Staff Report City of Richmond, Virginia

Commission of Architectural Review

| 7. COA- 142785-2024 | Final Review Meeting Date: 2 | 2/27/2024 |
| Project Description | Replace a steel fire escape with wood. | |

Figure 4. View of the fire escape on the south side of 23 South Arthur Ashe Boulevard. The new floor boards and their exposed decking can be seen on the second and third floors.

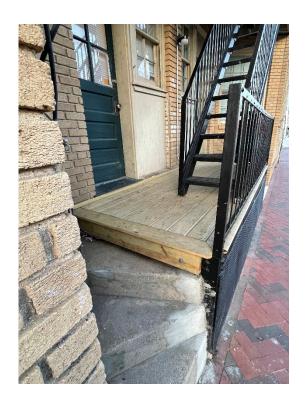
| Guideline Reference | Reference Text | Analysis |
|--|---|--|
| | On a site visit, staff noticed that the concrete floor of the fire escape had been replaced with wood. Staff recommends approval of the installation of wooden decking boards, as this element is minimally visible behind a steel fire escape framing. | |
| | | Staff recommends that a smooth material/underside that covers the decking's wooden joists be installed for a more finished appearance. |

| 7. COA- 142785-2024 | Final Review Meeting Date: 2 | 2/27/2024 |
|--|---|------------|
| Conditions for Approval | Staff recommends <i>denial</i> of the following: Replacement of the entire firescape with wood. Staff recommends <i>approval</i> of the below items with the foconditions: If the steel is beyond repair, staff recommends the replaced in-kind. Retention of the wooden decking boards The joists of the wooden decking boards must be screened by a smooth finish/underside for a more appearance. | e steel be |
